DUKE COGEMA
STONE & WEBSTER

26 August 2003
DCS-NRC-000156

Subject: Docket Number 070-03098
Duke Cogema Stone & Webster
Mixed Oxide (MOX) Fuel Fabrication Facility
Response to Request for Additional Information – Supporting MFFF Criticality
Validation Report (DSER Open Item NCS-04)

Enclosure 1
AOA (3) and AOA (4) Margin Discussion

**Figure 1. AOA3 Benchmark Data
Plot with Mean - Uncertainty
from Exponential Least Squares Fit (ELSF)
($y = A + B \cdot \text{Exp}(-EALF/C)$)**

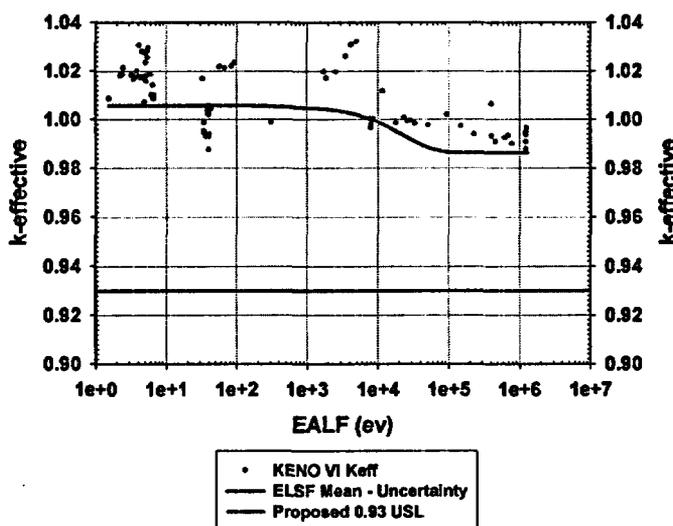
Shown in Figure 1 below is the data for AOA(3) trended with a fit of slightly higher order than the simple linear fit often used with the uncertainty included. The differences of the data from the fit (the residuals) have been analyzed by the standard, yet rigorous Anderson-Darling test for normality. The goodness of normality parameter (p-value) for that test is 0.2666 which indicates, since it is greater than 0.05, that the differences are normal. Thus, a conservative bound on the trend of the bias can be determined statistically and is also shown on the figure.

Taking the minimum value of the fit along with the maximum conservative statistically determined bound on the trend shows that a bounding value of 0.0108 in the bias and uncertainty in the bias would be expected to bound the performance of the KENO-VI code in calculating reactivity over the range of the benchmarks.

This value of 0.0108 in the bias and uncertainty in the bias is bounded by the currently calculated values of bias and uncertainty in the bias shown in the current validation report of 0.0155 for AOA(3).

**Figure 2. AOA4 Benchmark Data
Plot with Mean - Uncertainty
from Exponential Least Squares Fit (ELSF)
($y = A + B \cdot \text{Exp}(-EALF/C)$)**

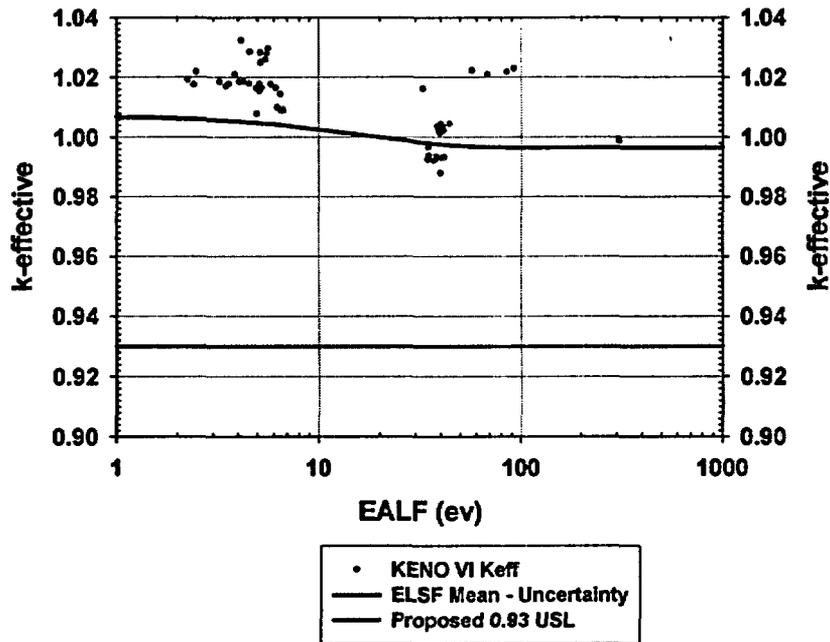
Similarly, shown in Figure 2 below is the data for AOA(4) trended with a fit of slightly higher order than the simple linear fit often used with the uncertainty included. The

differences of the data from the fit have been analyzed by the standard, yet rigorous Anderson-Darling test for normality. The goodness of normality parameter (p-value) for that that test is 0.095 which indicates, since it is greater than 0.05, that the differences are normal. Thus, a conservative bound on the trend of the bias can be determined statistically and is also shown on the figure.

Taking the minimum value of the fit along with the maximum conservative statistically determined bound on the trend shows that a bounding value of 0.0035% in the bias and uncertainty in the bias would be expected to bound the performance of the KENO-VI code in calculating reactivity over the range of the benchmarks.

This value of 0.0035 in the bias and uncertainty in the bias is bounded by the currently calculated values of bias and uncertainty in the bias shown in the current validation report of 0.0177 for AOA(4).

Figure 3. AOA3 Bias - Uncertainty Values

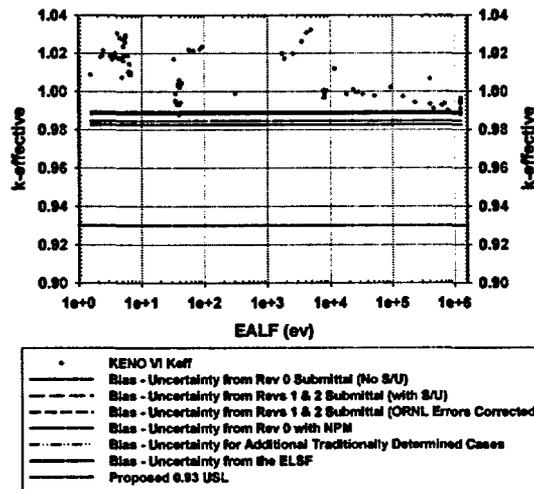
As noted previously, the ability of KENO to determine conservatively the reactivity can be analyzed in several ways. The number of benchmarks selected to determine the code accuracy can be selected in several ways. Shown in the following Figures 3 and 4 are

plots of the six ways discussed previously for AOA(3) and AOA(4) as a function of the traditional average energy parameter EALF (energy of average lethargy causing fission).

Note that in most cases, the determined bias and uncertainty in the bias is bounded by 2%. However, for the AOA(4) Case 4 in which the Revision 0 version of Part II contained only 14 experiments is shown, there is a large non-typical bias and uncertainty in the bias of about 6.5% due to the imposition of 4% NPM margin. However, this is an artifact of using only 14 experiments and not supported by other methods of determination. Clearly, as shown previously, with a more reasonable number of experiments, a bounding value of bias and uncertainty in the bias would be more consistent with the 2% value observed as a bounding result for the other methods presented here.

As can be seen, the bias and margin DCS has committed to using, as required by NUREG-1718, is 7%. This results in a maximum calculated k_{eff} of 1-0.07 of 0.93.

However, as can be seen in the figures, a conservative estimate of bias and uncertainty in the bias, as would be expected, is only about 2%, except in the artificial case of analysis of only 14 experiments for AOA(4) and the application of corresponding large NPM margin. Use of the conservative value of 7% bias, uncertainty in the bias, uncertainty in the data, and the method, results in a very large safety margin (7% vs. about 2%).
